VWC3 Third Submittal Response

PROJECT: Village at Westerly Creek III (DA-1639-01, Case # 2009-4001-02)

Below are my responses to the Second Submission Development Review comments.

Re: Second Submission Review – Villages at Westerly Creek Phase 3 – Site Plan – Comment Response

SHEET TITLE:
BUILDING 01NORTH AND SOUTH
ELEVATIONS

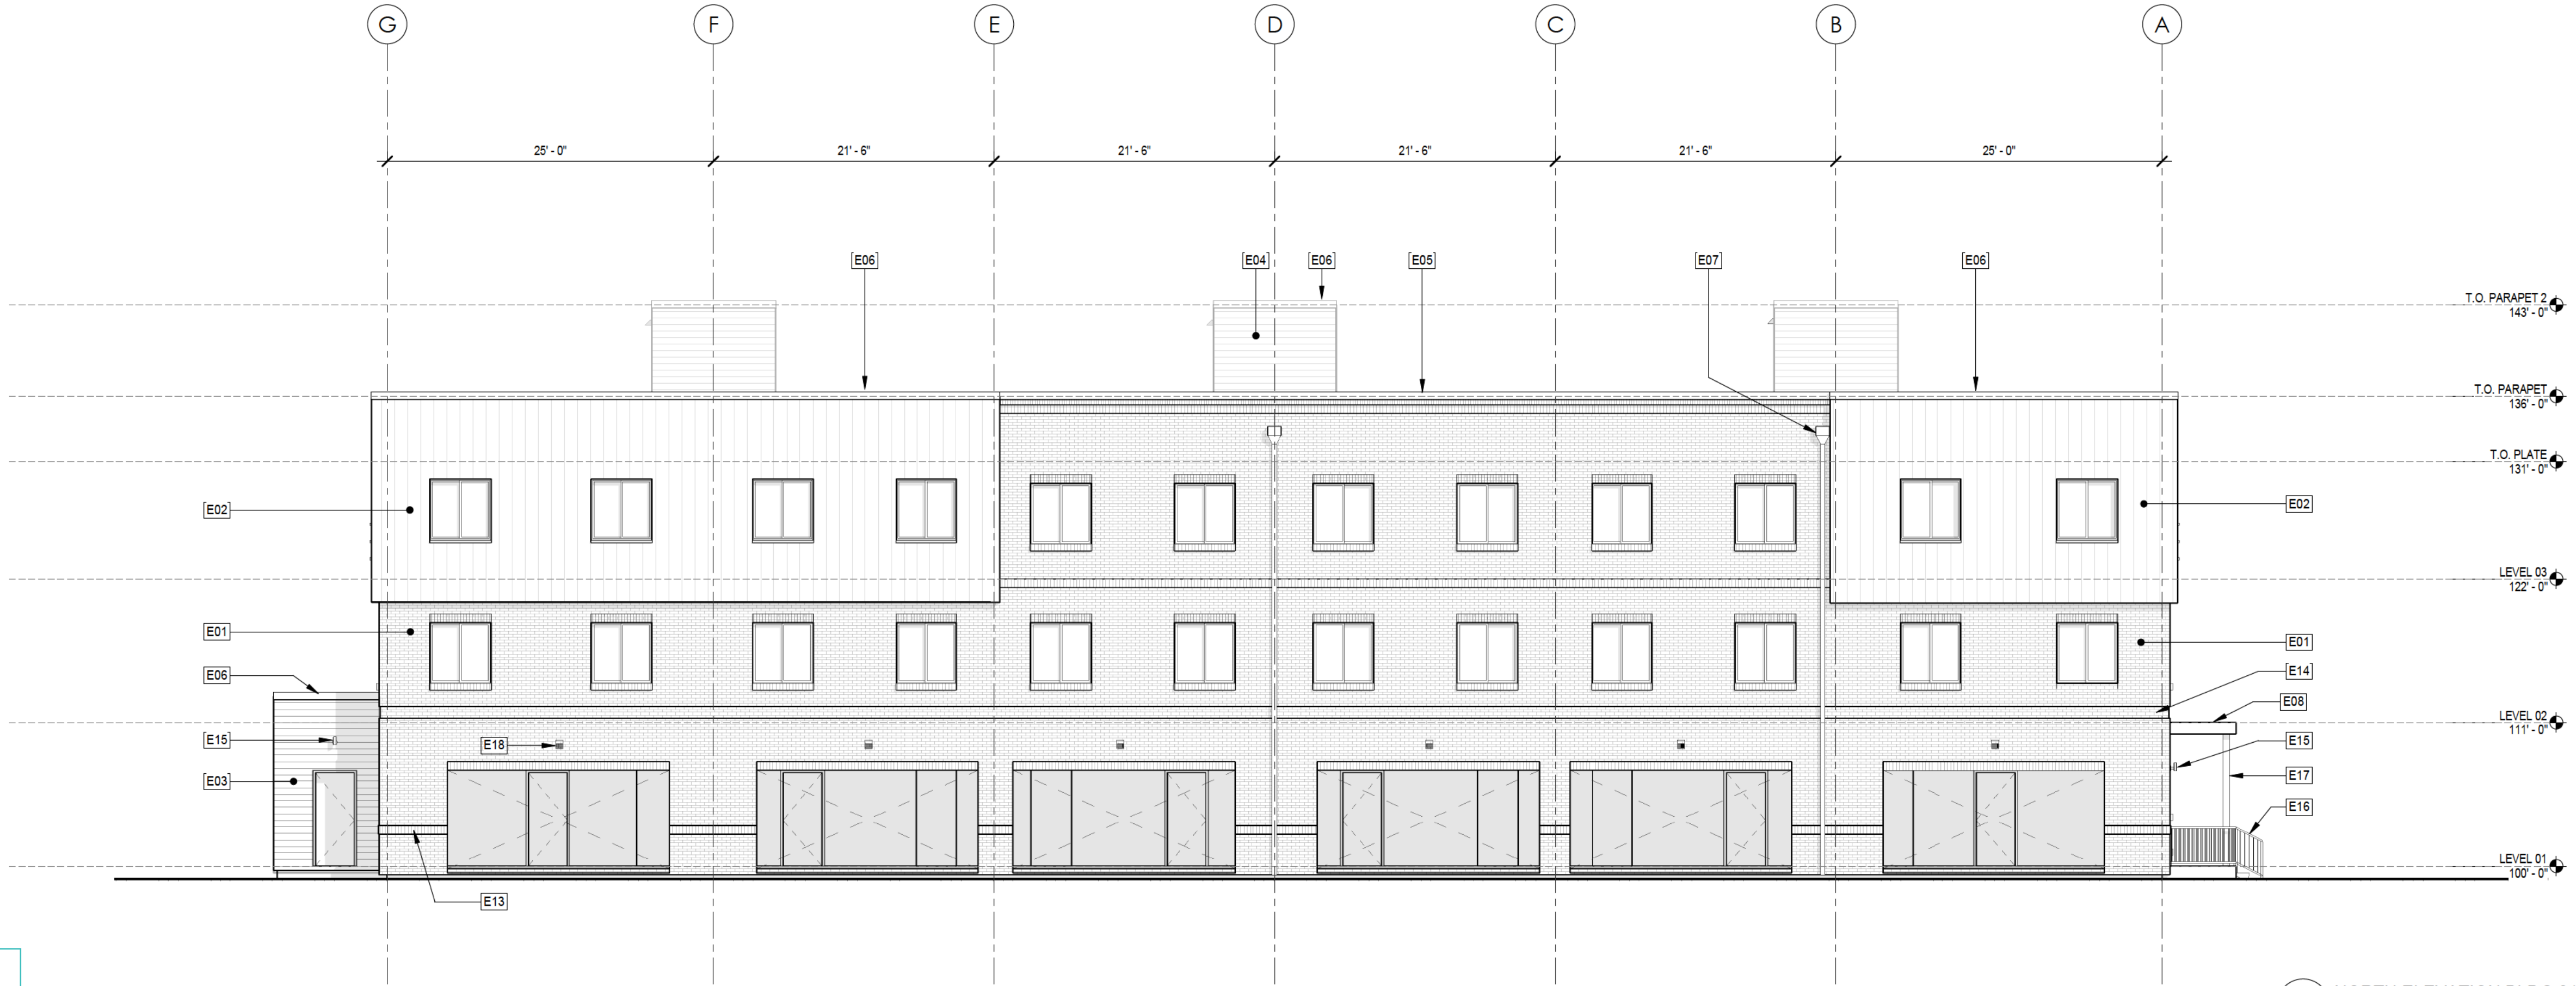
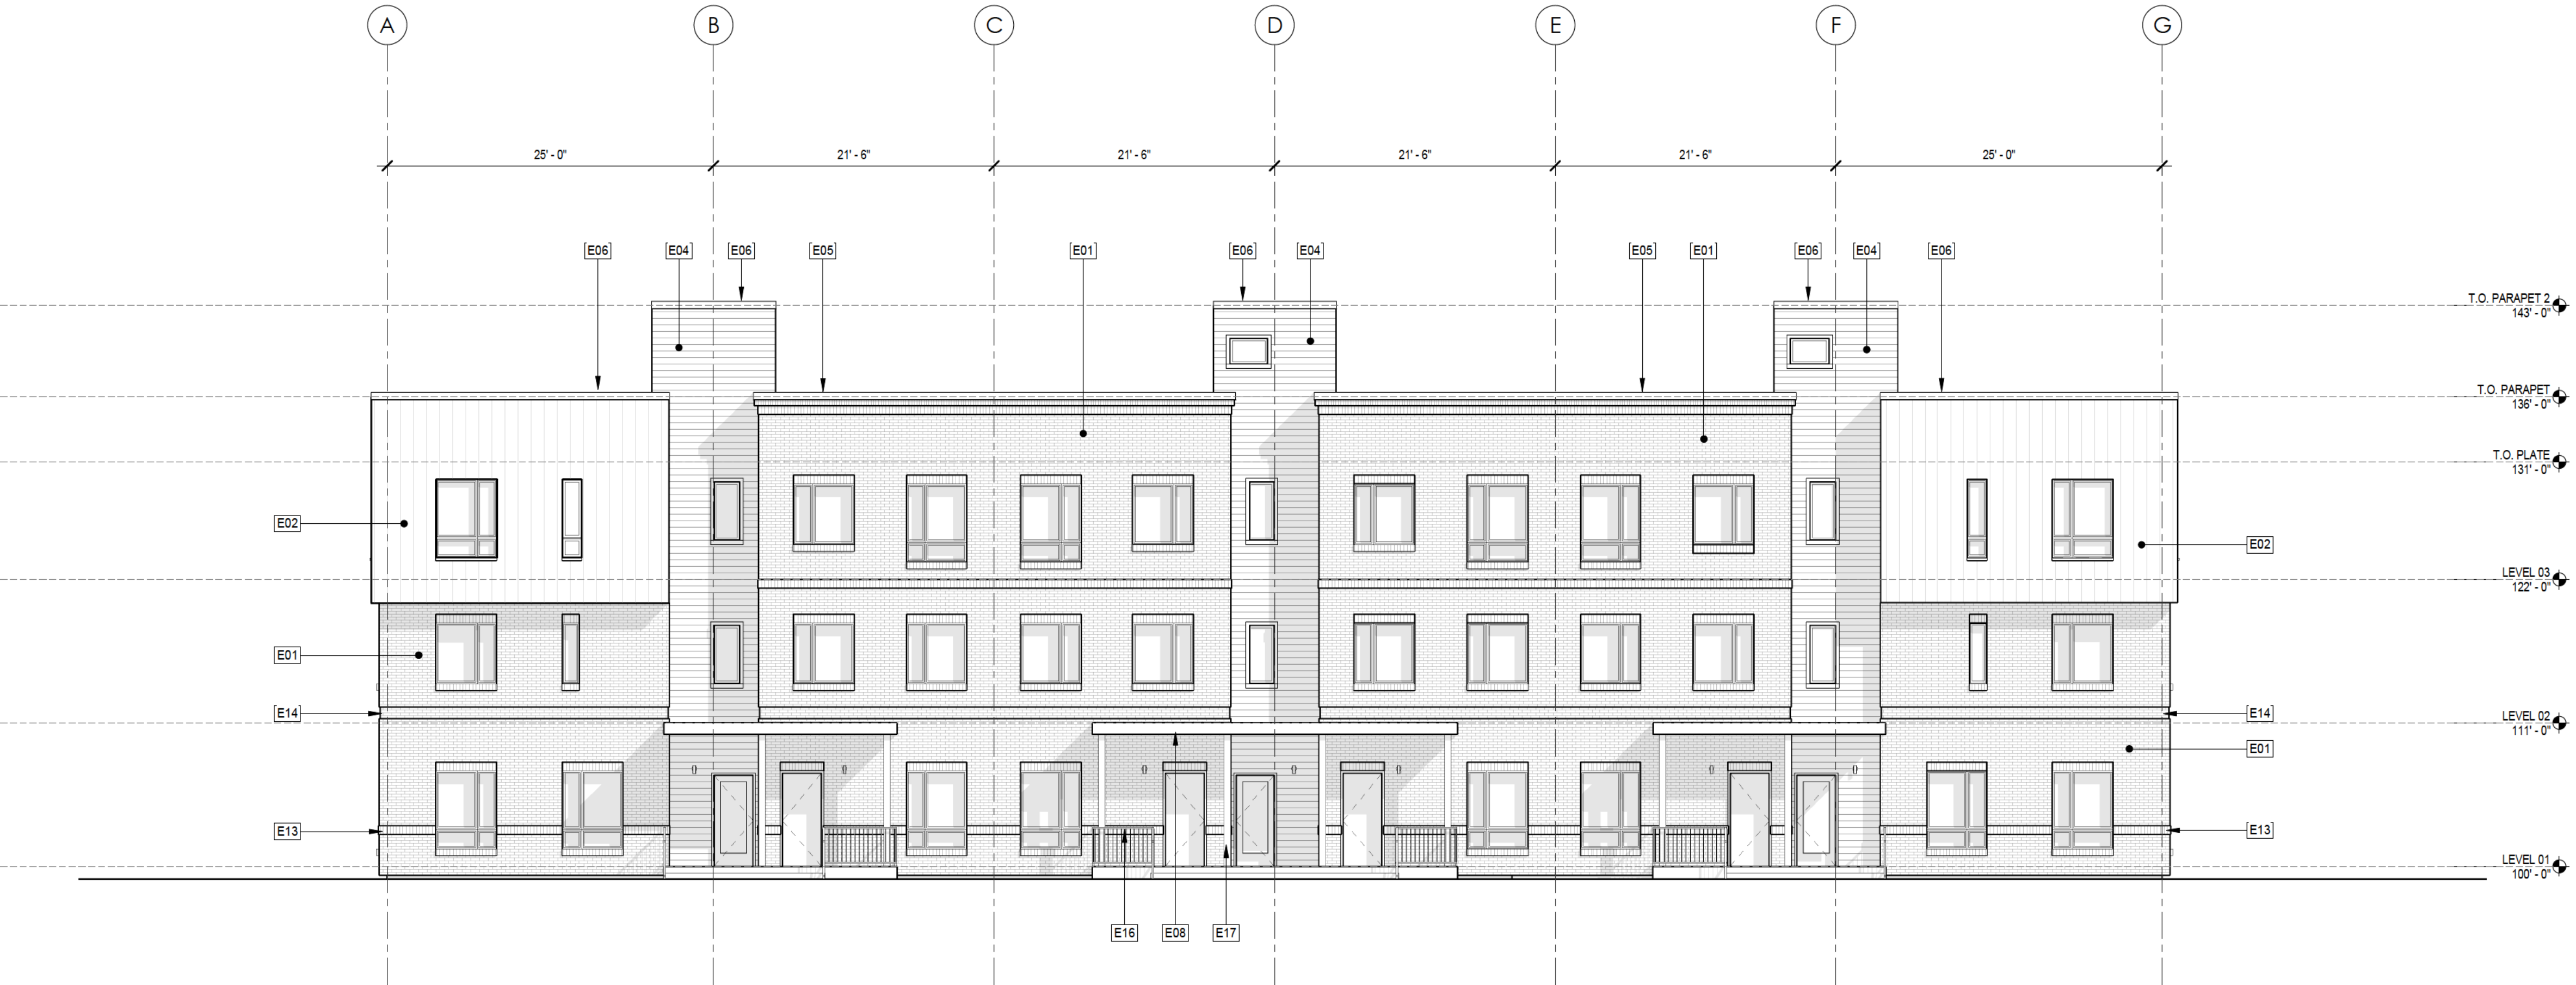
For each elevations sheet, provide a vicinity map highlighting the building location

Indicate rooftop equipment on all elevations with a dashed line.
You will need to request a waiver to allow for roof top equipment to not be screened.

If covered detached parking structures are part of this Site Plan, elevations for them should also be included.

Coordinating with the Utility plan comments, the Exterior Elevations shall show and label the locations of:

1. Fire Department Connection, "FDC WITH APPROVED KNOX PLUGS"
2. Fire riser room with permanently affixed "FIRE RISER ROOM" sign detail on the exterior door
3. KNOX BOX(ES) MOUNTED 4-6 FEET ABOVE FINISHED GRADE (Typical Elevation sheets 19 thru 31)

Is entire development addressed as 830 S Ironton?
How are individual buildings and units addressed?
Please clarify on the monument sign detail on Sht. L-11 and Building Elevations.

- C. The 4 trees in question have been added to the park area.
- 5. Architectural and Urban Design Issues
 - A. Rooftop equipment has been indicated as a dashed line on all Building Elevations.

- C. Vicinity maps have been added to all Building Elevations and Renderings.
 - D. Material percentages have been added to all Building Elevation sheets.
